REPORT AMENDED BY STAFF 2-26-87
CITY PLANNING COMMISSION

- APPLICATION:**
- A. Negative Delcaration
 - B. Amend Sunset Meadows PUD Schematic Plan to designate a church site in place of Single Family Residential for 12.3 ± acres
 - C. Special Permit to construct a 2 Phase church project with a total of 39,690 square feet of building, 560 fixed seats and 1,842 total seats in the Townhouse PUD (R-1A-PUD) Zone.
 - D. Variance to exceed 35 feet height limit by 11 feet.

LOCATION: North side Rio Tierra Avenue 600± feet west of Northgate Boulevard.

PROPOSAL: The applicant is requesting the necessary entitlements to construct a 2 phase church with a total of 39,690 square feet of building area, 560 fixed seats and 1,842 total seating capacity.

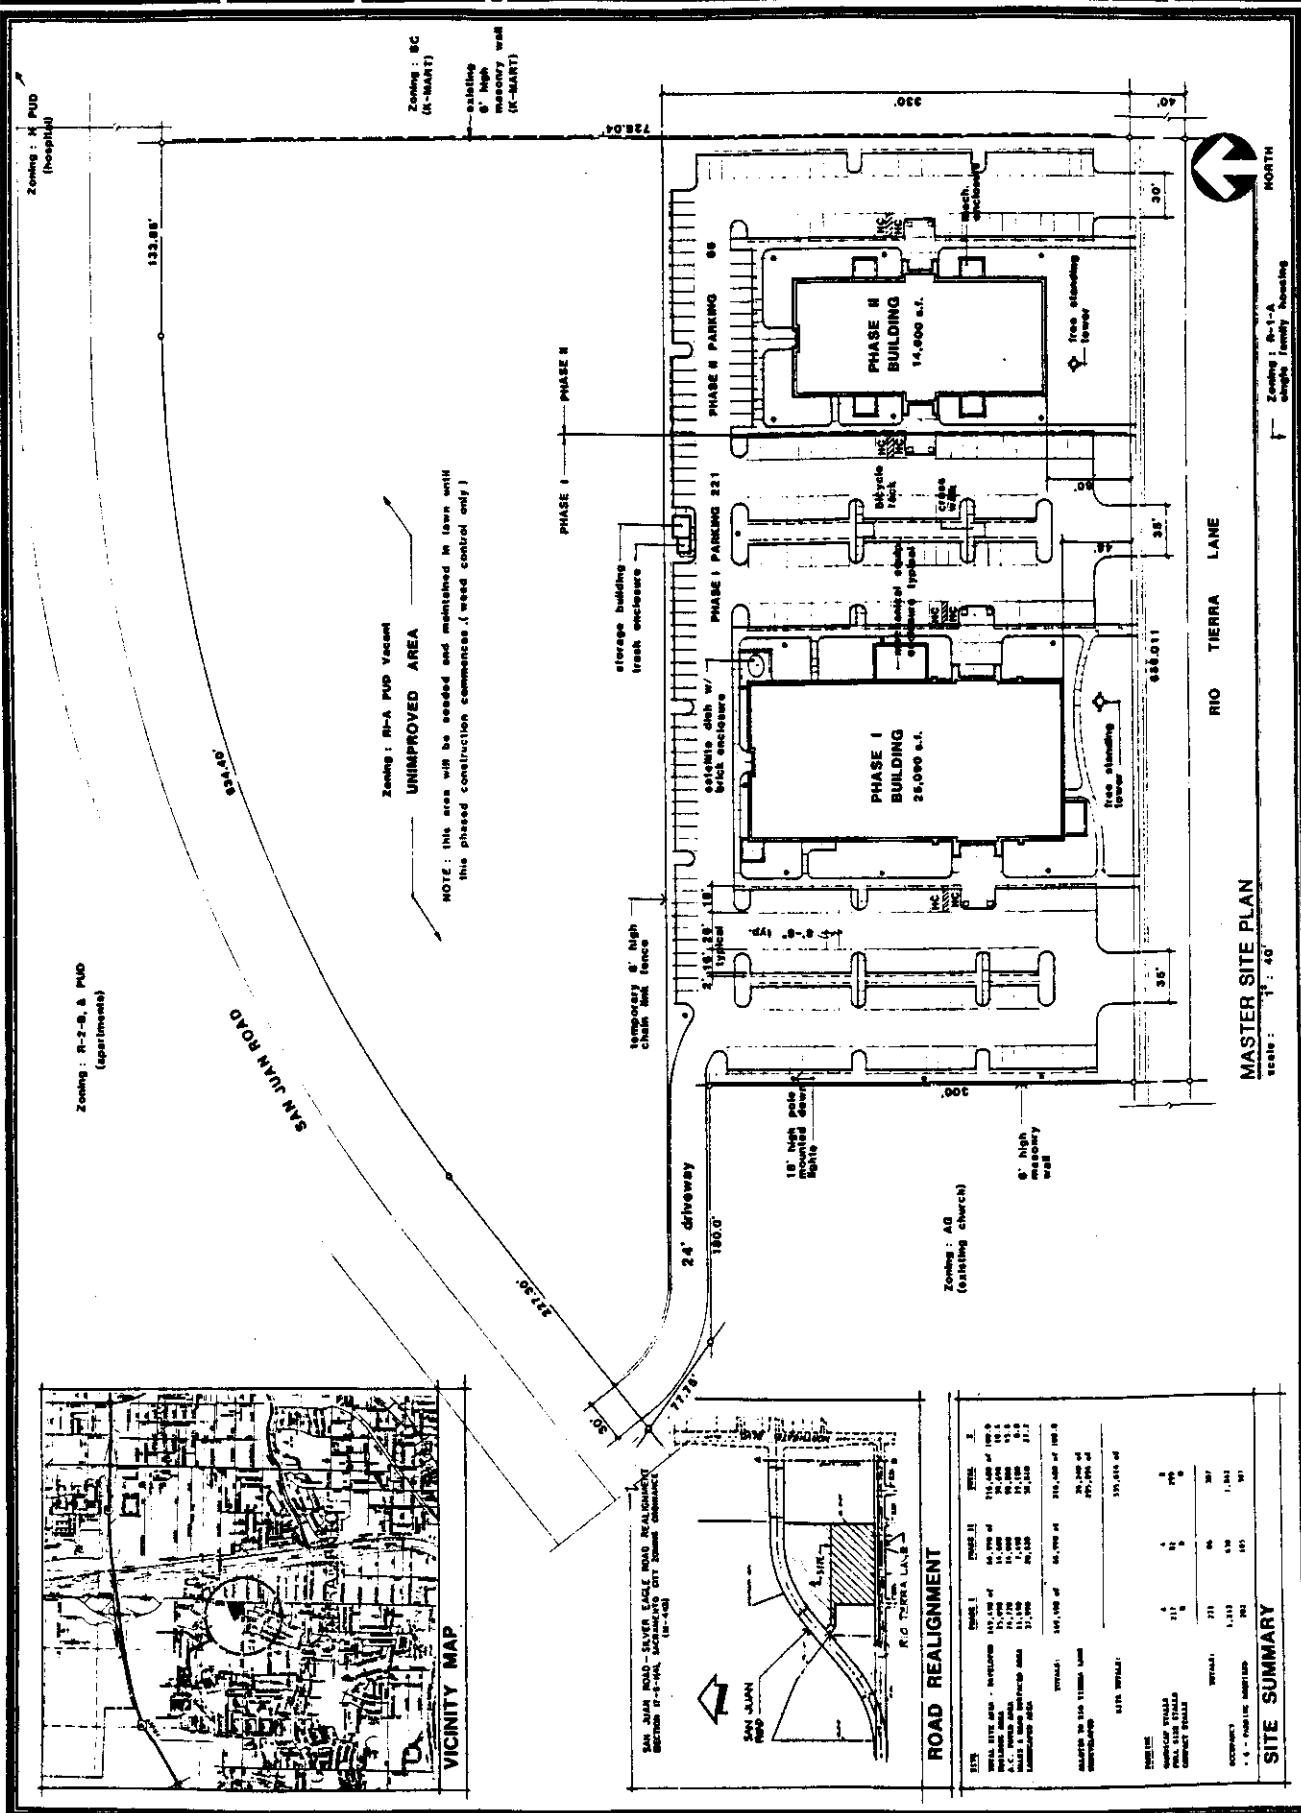
The applicant's site plan shows no development along the San Juan Road frontage for approximately 6 acres of the site. The area is proposed to be seeded and maintained for weed control only. A temporary six foot high fence is proposed along the northern limits of development separating the parking lot from the vacant north half of the site. The eastern property line abuts a proposed K-MART Site, P86-362, which includes provision of a 6 foot high decorative solid masonry wall as a condition of its Special Permit.

A six foot high masonry wall is proposed along the western property line separating the existing Lutheran Church and pastor's residence from the proposed project. No fencing is shown along the south side of the driveway off San Juan Road. Staff recommends that a *six foot high masonry wall or decorative fence consisting of masonry pillars and solid wood board* be continued from the west property line along the property line to San Juan Road. A minimum four foot planter should be designed into the wall area between the property line and driveway north of the Lutheran Church. The wall should not exceed 3 feet in height within the 25 foot front yard setback along San Juan Road or Rio Tierra Avenue. *(staff amended)*

The City Traffic Engineer commented that the proposed San Juan Road driveway should be 13 feet from the property line. A three foot outward flair is required on driveway curbs.

The City Traffic Engineer recommends that the "T" entrances to the west and center driveways off Rio Tierra Avenue be eliminated and realigned to be in line with one of the driveways. Staff prefers the applicant's site plan in that long rows of parking are not as visible if the "T" driveway is maintained from the residentially zoned and used property south of Rio Tierra Avenue.

The Traffic Engineer also noted that prior to approval of driveway locations, the applicant is required to show all intersections adjacent to the site. Those driveways which create adverse circulation conditions are to be redesigned or relocated.

Staff recommends that the foundations for the spires be located behind the building setback line of 25 feet from the public right-of-way along Rio Tierra Avenue.

1. The proposed church buildings shall be developed per the submitted site plan and elevations including phasing limits.
2. A minimum of 220 parking spaces shall be provided for Phase I.

4. The applicant shall show a 6 foot high solid decorative masonry wall along the west property line separating the Lutheran Church from the proposed church. The wall *along the driveway* shall extend to San Juan Road and *for this portion be constructed of masonry pillars and solid wood boara fencing*. Maximum height of the wall within 25 feet of Rio Tierra Avenue or San Juan Road shall not exceed 3 feet. (*staff amended*)

7. The parking lot shall be redesigned to comply with the requirements of the City Traffic Engineer. Minimum City standards shall apply for stall dimensions and backout maneuvering area.

9. Driveways off Rio Tierra Avenue shall be relocated to the satisfaction of the City Traffic Engineer regarding alignment with existing streets south of Rio Tierra Avenue.

21. The spires shall be set back a minimum of 25 feet from the public right-of-way.
22. The spires shall not be illuminated, either externally or internally.

LANDSCAPE PLAN • PHASE II
 SCALE: 1" = 20.0'

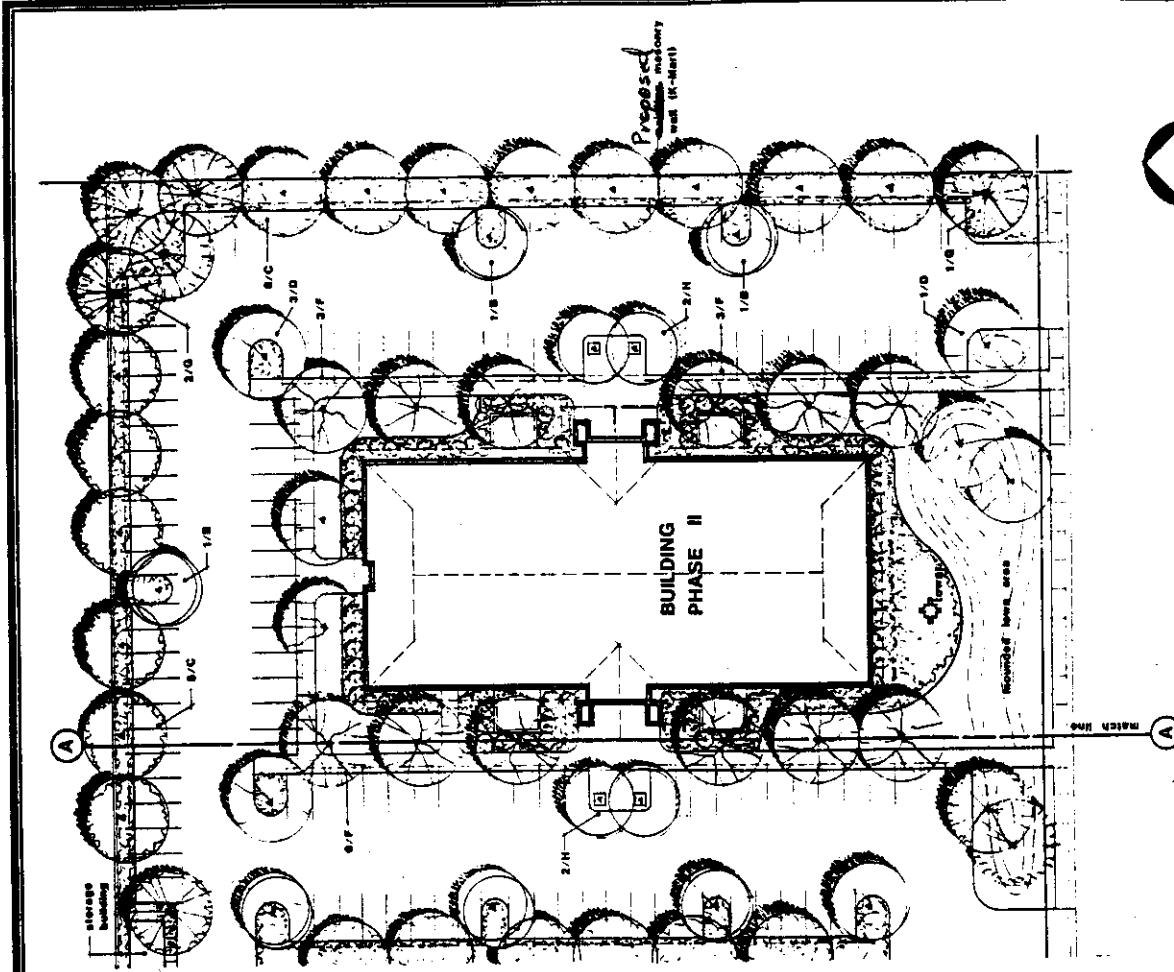
The applicant's plan show detailed landscaping which meets the 50 percent shading ordinance requirement. Staff notes that the Phase II area, prior to development, is proposed to be seeded in grass and irrigated and mowed during the summer months. Detailed landscaping plans should show the use of living groundcover on all exposed areas. Use of bark, mulch, rock or similar materials should not be allowed.

Along Rio Tierra Avenue, a 48 foot building setback is observed with a 4 foot high undulated landscaped berm covered with lawn. Staff notes that the Phase I spire is located 23 feet from the front property line. Staff recommends that the spire be set back a minimum of 25 feet from the Rio Tierra Avenue property line as required for any structure in the R-1A Zone.

The parking stalls include a 2 foot vehicle overhang into a landscape strip. No portable concrete wheel stops are shown. Staff recommends that all landscaped areas be bordered by a 6 inch poured-in-place concrete curb and that no portable concrete wheel stops be used.

3. The applicant shall submit detailed revised landscaping and irrigation plans showing the following:
 - a. 50 percent shading within 15 years of planting for all paved surfaces.

- b. Use of living ground cover on all exposed earth areas. The Phase II building area shall be planted in lawn and maintained. The north vacant area shall be mowed, kept clean of rubbish and not create a visual, dust or fire hazard.

- c. A two-foot vehicle overhang shall be designed into the planters adjacent to parking stalls.
 - d. Evergreen trees shall be planted along the east and west property lines to create a year-round visual buffer from adjacent parcels.

16. The applicant shall submit a signage program for review and approval by the Planning staff prior to issuance of sign permits.
17. The proposed landscape setback along Rio Tierra Avenue shall have undulating 3 to 4 foot high berms with lawn and 15 gallon trees. Staff recommends clustering trees in appropriate locations to provide screening of the parking lot and emphasis on the building's visibility.

PHASE I BUILDING ELEVATIONS
 SCALE: 1/8" = 1'-0"

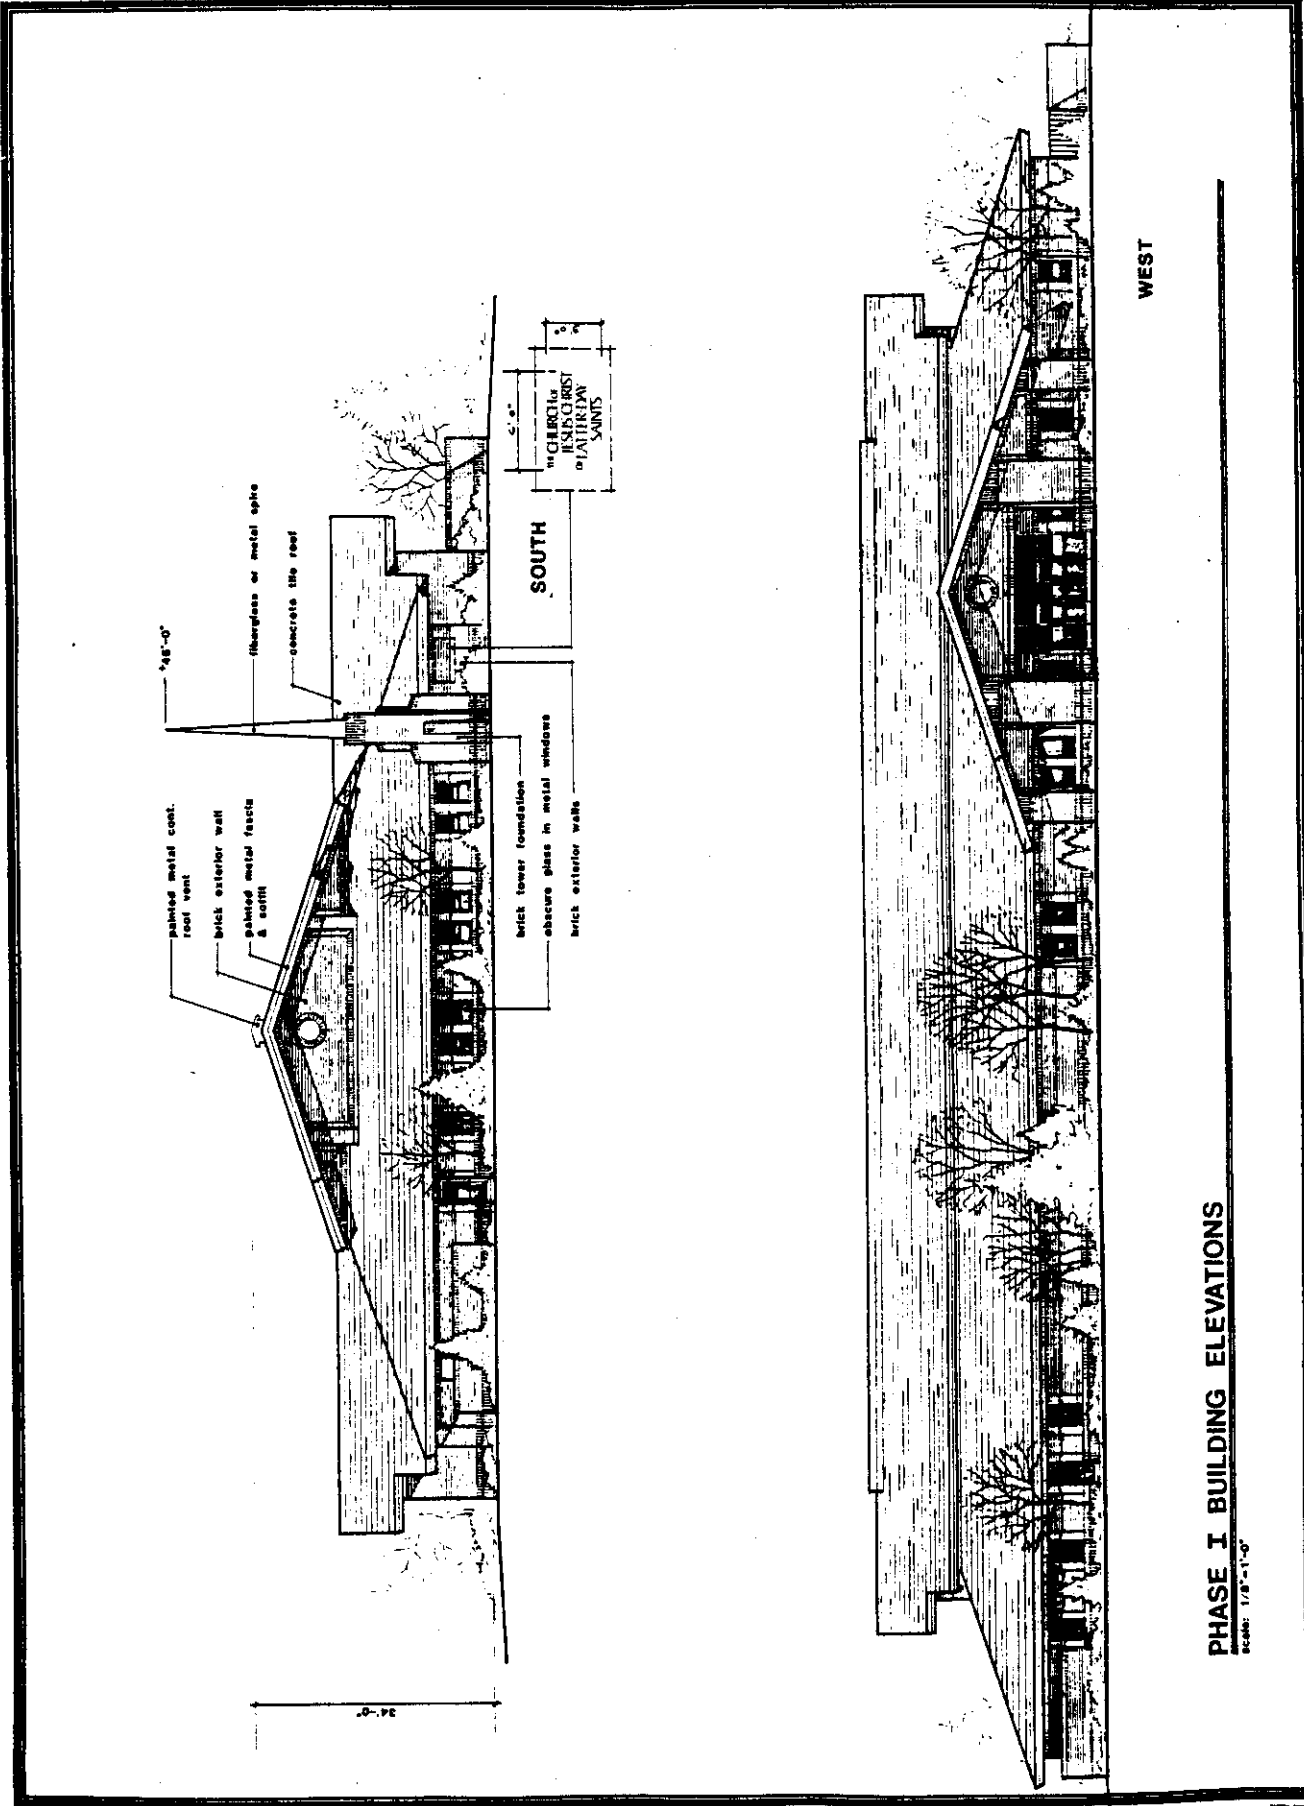
Both proposed buildings will be constructed with a similar single story horizontal profile. Materials are proposed to be brick, metal trim, concrete tile roof and obscure glass in metal windows with a concrete slab foundation. The brick will be placed in various patterns from soldier course, running bond field double soldier course, and reveal course over the exterior elevations. No colors were indicated for the brick or painted metal surfaces. Staff recommends that the applicant submit color board and materials samples to the Design Review staff for review and approval prior to issuance of building permit. Included should be the material used in the spire.

The two spires, 46 and 36 feet in height, will be constructed with a brick base and the towers will be constructed of either metal or fiberglass material. No colors were indicated for type spires. According to the Zoning Ordinance, roof structures erected on top of a building not exceeding 50 percent of the roof area may extend 20 percent into the maximum height allowed in that zone. Twenty percent of 35 feet is 7 feet so that the spire, if attached to the building, could be 42 feet in height.

As a detached structure, the circumstance for considering the height variance is unique. Prior consideration by the Commission on similar requests for church spires were attached to the roof, not a detached structure. Staff observes that the function is similar to a flag pole indicating a specific location and use. The proposed spires are architecturally compatible with the main buildings. Staff concurs with the applicant's statement that spires are found with church developments and that their design will enhance building identification for church members. Since the function of the detached spire is similar to the attached spire referenced in the Zoning Ordinance, and the 42 foot height limit is proposed to be exceeded by 4 feet, staff anticipates no problem in supporting the height variance for both spires.

10. The applicant shall submit a materials and color board for all structures proposed on the site to the Design Review staff for approval.
11. The applicant shall monitor the use of the San Juan Road access as a short-cut to Rio Tierra Avenue. If a problem arises, restrictions on access should be constructed. If a gate is proposed, it shall be a minimum 25 foot setback from the San Juan Road right-of-way.

23. Material and color of the spire shall be reviewed and approved by the Planning Director prior to issuance of building permits.
